UCD Ballsbridge
to City Centre
Core Bus Corridor
– 1st Non-Statutory
Public Consultation
Submission Report

Corridor 14 – UDC to Ballsbridge

Emerging Preferred Route – Public Consultation Report 2018/2019

Figure 3: Section 1 UCD to Nutley Lane

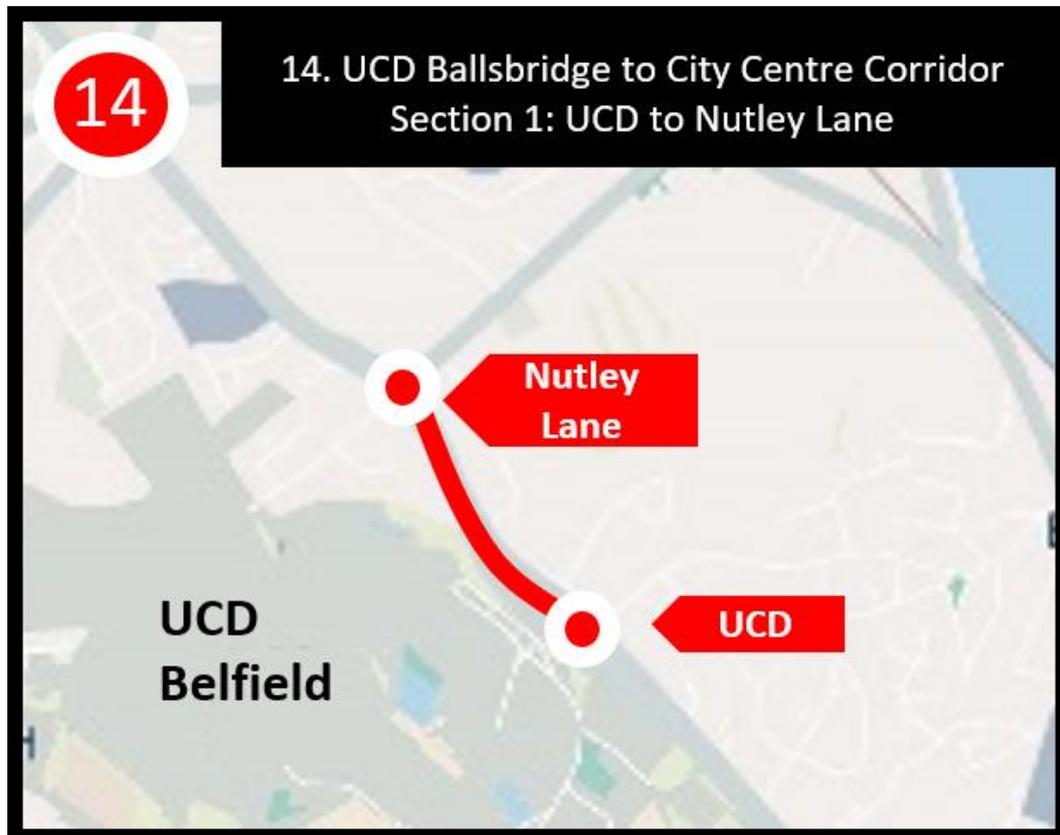
- A concern which arose in submissions generally related to Nutley Lane, the right-turn movement of buses from the R138 at the western extent of Section 1. Although it was detailed in the public consultation drawings it is viewed as being potentially unsafe and unclear, given the need for a bus to stay left and then cross three lanes of traffic into town.

Figure 4: Section 2 Nutley Lane

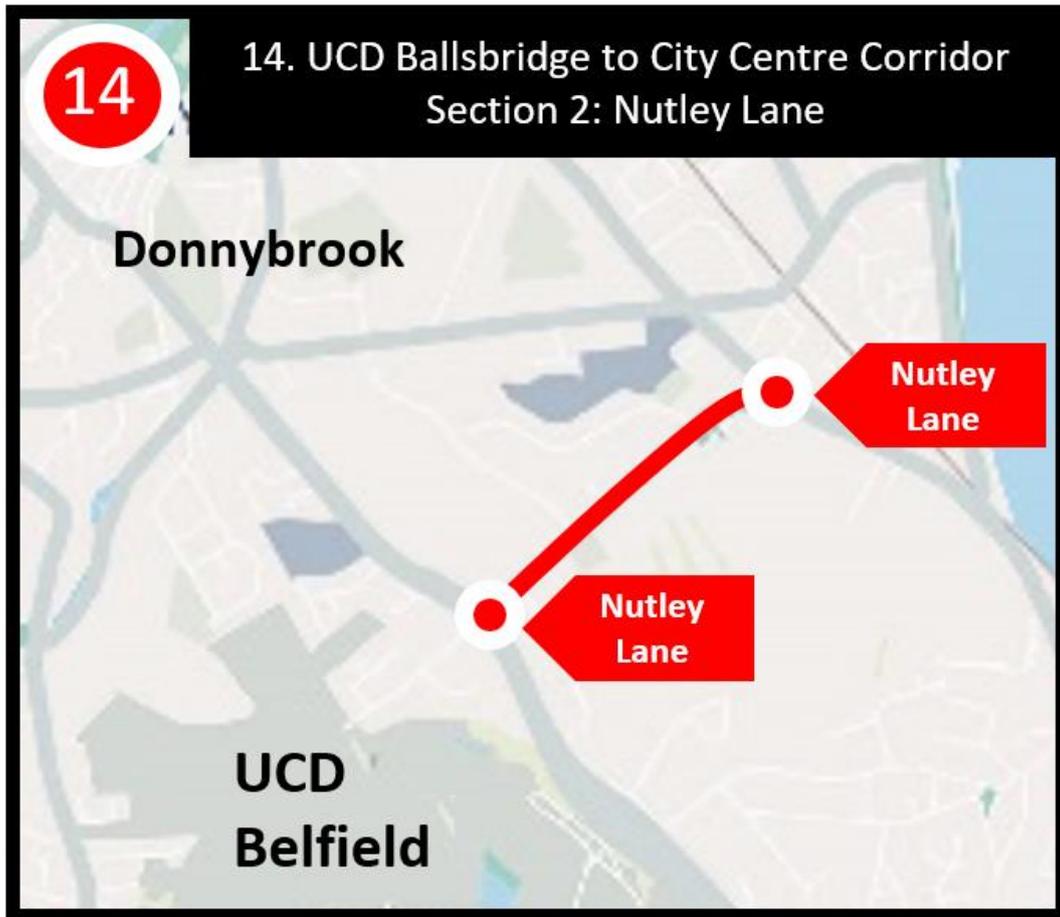
- A large number of submissions were based around the likely increase in the cross section of what is currently perceived as a residential road with through traffic. Concerns regarding a potential induced demand effect were raised, citing traffic studies which have shown that road widening does not always provide long term increased capacity – and a number of submissions suggested that the presence of a junction on each end of the road could possibly negate the additional capacity provided. Some residents proposed alternative arrangements such as reducing the proposed cross section to two bus lanes, and a single traffic lane (perhaps from R138 as far as the Hospital entrance, then becoming two-way, or alternating eastbound and westbound in AM and PM), along with other potential amendments such as a single two-way cycle track on the Elm Park side or having no footpath provision from Elm Park Golf Club Entrance to the Hospital entrance (on east side) as the main demand on this side is from those parking.

- The removal of on-street trees and those in front gardens was highlighted as a concern amongst residents. The concerns relate mainly to aesthetics of area, environmental concerns (both carbon absorption and biodiversity aspects), and the coverage provided from sun and rain. Alternative suggestions included a recommendation to create a central median with linear mature trees in a boulevard cross section, with land take for same focussed on the Elm Park side. Many submissions note that there is little evidence of new trees being provided like-for-like or a compensatory planting strategy.

- There were concerns expressed that sufficient detailed surveys have not been carried out to permit proceeding with the plan, including socio-economic, traffic, topographical, environmental, and underground services.

- Likewise, a number of submissions question the need for both cycle and bus provision on Nutley Lane, with alternative suggestion for cycle lanes being Woodbine Road or Booterstown Avenue.

- It is stated on a number of occasions that there are historic streams / rivers in this area, many of which have been culverted, and possibly a high-water level. Some submissions have expressed concerns of flooding given the proposed increase in hard standing area associated with this plan. There were some related concerns about access to the various services including these culverts

- A number of residents were also concerned with the locations and number of bus stops, suggesting the possible added noise and vibrations so close to residential homes could be disruptive.
- Some submissions raised concerns with regard to potential impacts on local sports facilities.

Figure 5: Section 3 Nutley Lane to Sandymount Avenue

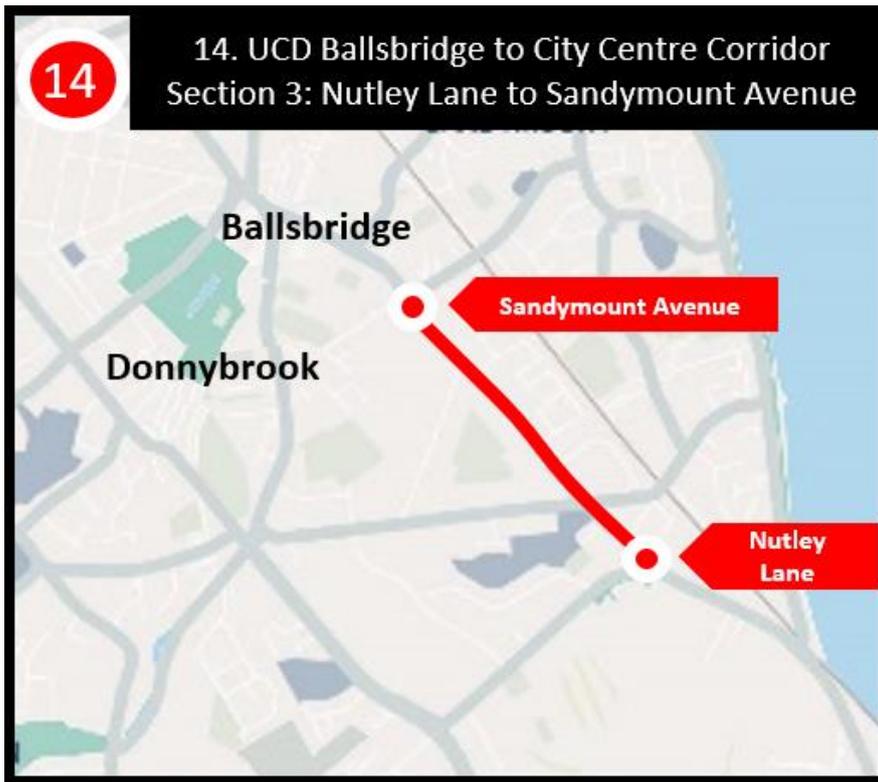
- The potential removal of on-street mature trees and those in front gardens was also a cause for concern amongst residents. The concerns relate mainly to aesthetics of area, environmental concerns (both carbon absorption and biodiversity aspects), and the coverage provided from sun and rain. Many submissions suggested that there is little evidence of new trees being provided like-for-like or a compensatory planting strategy.

- It was claimed in some submissions that although there were tree report and surveys carried out, the results do not consider the higher level environmental benefits of urban trees. Submissions referenced examples such as the current funding programme in the UK for planting of trees in urban areas to mitigate rising temperatures, and a Dutch study which supported this thinking in showing that tree shading of hard standing can reduce local summer temperatures.

- There were concerns raised that existing bus routes will be lost, and the proposed services are either not sufficient or the plans provided do not detail them enough to alleviate concerns. In particular the 1 and 47 are noted as valuable local services that are used by many locals and not just commuters. The 17 and 18 are also noted as well used local buses.

- It is suggested that the current plans indicate the closure of an entrance to an established access to the back of some residential properties on Merrion View Avenue, and that no alternative is indicated. It was suggested that this is an established right of way which is heavily used.

- Some concerns were expressed that sufficiently detailed surveys have not been carried out to permit proceeding with the plan, including socio-economic, traffic, topographical, environmental, and underground services.

Figure 6: Section 4 Sandymount Avenue to Shelbourne Road

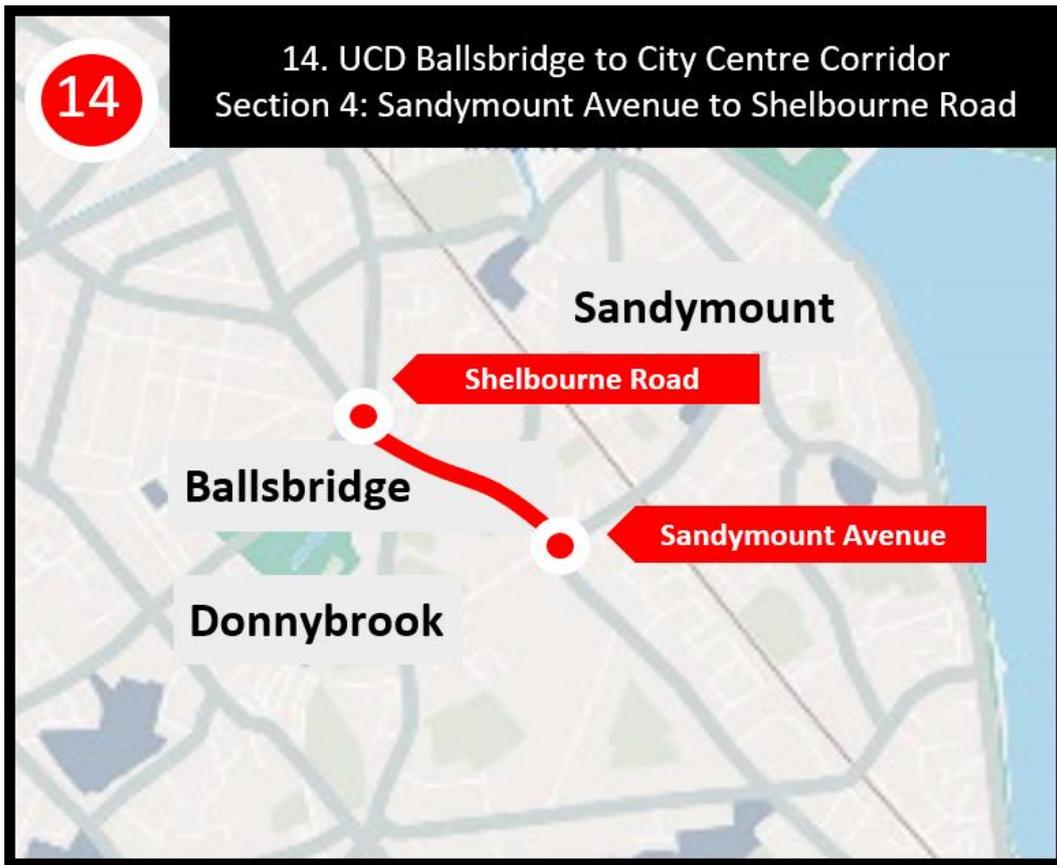
- The removal of the left turn movement onto Elgin/Clyde Road is queried and there are also alternative suggestions that Herbert Park be made a no through road rather than Eglin/Clyde Road to enhance the park function and remove cars.

- As with other sections, the removal of on-street mature trees and those in front gardens was highlighted as a cause for concern amongst residents. The concerns relate mainly to aesthetics of area, environmental concerns (both carbon absorption and biodiversity aspects), and the coverage provided from sun and rain. It is suggested that in particular in the Ballsbridge area the trees form an important part of the history and lives of those living in the area. Many submissions note that there is little evidence of new trees being provided like-for-like or a compensatory planting strategy. It is also claimed that the public consultation maps are seen as misleading as regards trees to be retained, as it is not made clear that many of them on the drawing are in private lands.

Figure 8: Section 6 Eastmoreland Place to Baggot Street Lower

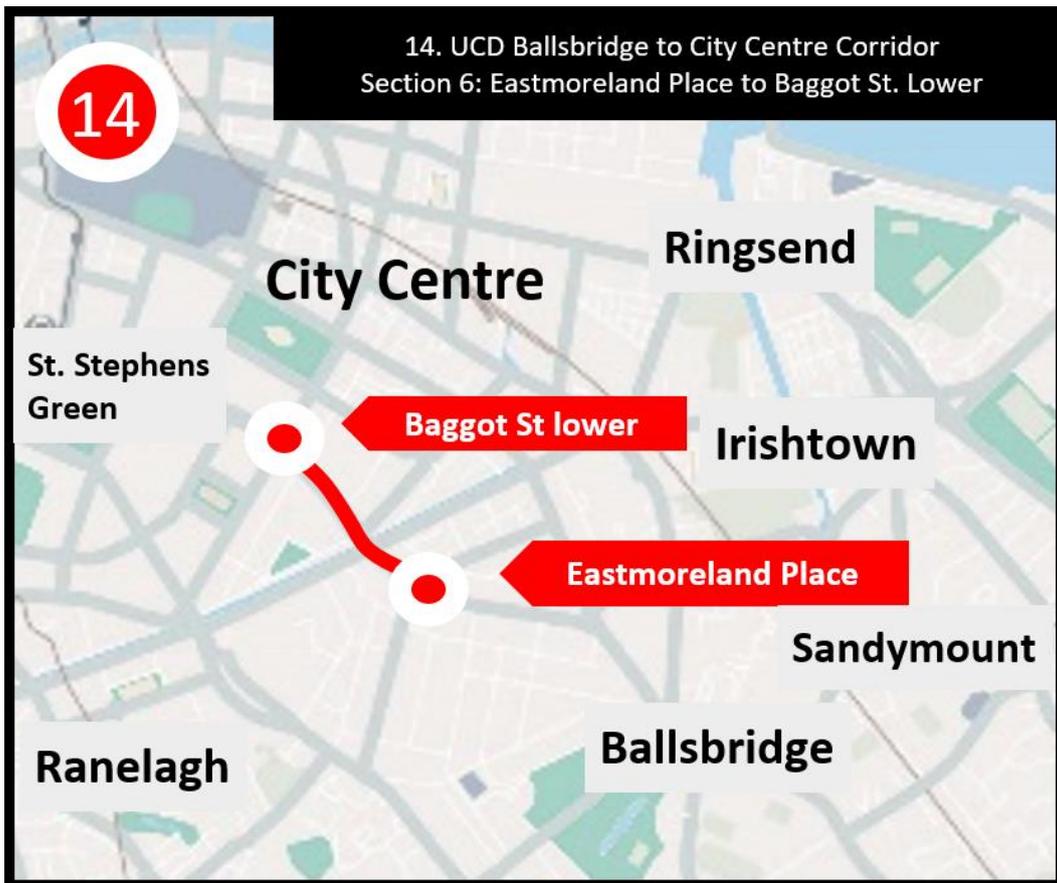
- There were some concerns raised that the plans may not make it any safer or attractive for cycling, as one of the main detractors from cycling is the fumes from cars and buses. A number of submissions opposed the non-segregated nature of the cycle provision and the need to mix with bus and vehicular traffic. It is suggested that an alternative cycle route through safer streets be developed.

- A number of submissions questioned the options assessment and data collection process in determining the route and the proposed cross section as being the preferred option over all alternatives. There is a perceived lack of information on the assessment and a perceived lack of justification / supporting evidence for the works – and a fear that if this solution is carried out and is then determined to not be fit for purpose, the impact will be irreversible. The proposals are suggested by some as a short-term solution and other alternatives such be considered such as underground metro, underground road network, congestion charges, taxing free parking spaces, or increasing park-and-ride facilities.

- The proposed routing of buses along Baggot Street is questioned, mainly in relation to what is planned for buses approaching Baggot Street / Fitzwilliam Street junction (end of Route 14) and how the tie-in to the existing cross section could potentially create bottlenecks and detract from the time savings achieved.

- Numerous submissions suggest that there is little evidence of new trees being provided like-for-like or a compensatory planting strategy. It is also suggested that the public consultation maps were seen as misleading with regards to trees to be retained, as it was not clear if many of them on the drawing are in private lands and that the maps do not indicate the trees which are being removed. Some submissions suggested that the trees being removed are known and should be highlighted on the drawings to describe the true impact.
